PREPARED FOR THE URBAN DESIGN COMMISSION

Project Address: 630 E Washington Avenue
Application Type: Redevelopment of the Salvation Army Campus Located in UDD No. 8 – Final Approval is Requested
Legistar File ID # [56474](#)
Prepared By: Jessica Vaughn, AICP, UDC Secretary

Project Description: The applicant is seeking Final Approval to construct a five-story building with a mission house, rooming house, counseling services, health services and place of worship, and a separate three-story, 40-unit apartment building.

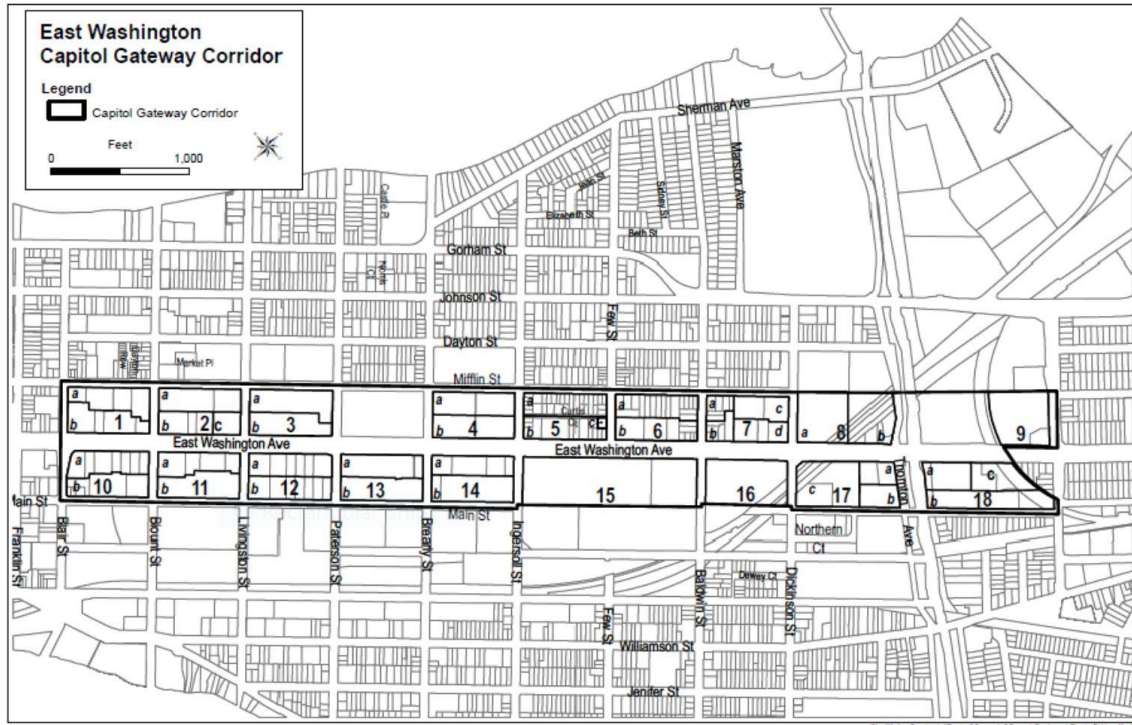
- **Block 1a and b Transition along N Blount Street.** The project site is located within UDD 8, Block 1. The subject block is divided into Blocks 1a and 1b, with each district containing different building height requirements. While the dividing line between sub-districts is typically mid-block in most parts of UDD 8, the dividing line in the subject blocks follows existing property lines as shown in the image below.

UDD 8 has a building maximum street level façade height of five stories for Block 1b and three stories for Block 1a. Block 1b extends roughly 90 feet from E Washington Avenue, north along N Blount Street, where Block 1b begins. As shown on the floor plans, the proposed shelter building extends approximately 111 feet from E Washington Avenue north along N Blount Street. Based on the current UDD 8 street façade height restrictions, a stepdown to 2-3 stories would be required 90 feet into the site to meet the Block 1a height requirements. Staff estimates that this impacts roughly 20 feet of the façade along N Blount Street.

Staff notes that this aspect of the building has not changed since the original submittal and initial approvals. While not previously identified, the UDC’s previous Initial Approval does not waive the underlying code standard and plans must either be revised to meet the current code, or the ordinance changed to shift the location of this boundary. Staff is supportive of the code change as it would create consistency with other blocks and would allow for the development to proceed as previously approved by the Plan Commission and Urban Design Commission. At the time of report writing, staff has discussed the change with the District Alder and a formal amendment to the code is being prepared for consideration. The code amendment will require separate review by the UDC and action by the Common Council. Staff has discussed the timing consideration with the City Attorney’s Office, and has been advised that the UDC has the option to conditionally approve the item. If the Commission wishes to do so, staff has recommended **Condition 1, below**.

1. Prior to final sign-off and the issuance of permits, plans shall be found to comply relevant height and bulk standards for Blocks 1a and 1b. Based on the current plans, the building shall be revised or a subsequent adjustment to the boundary between Blocks 1a and 1b in UDD 8 shall be approved by

the Common Council prior to sign-off. This information shall be approved by the UDC Secretary.
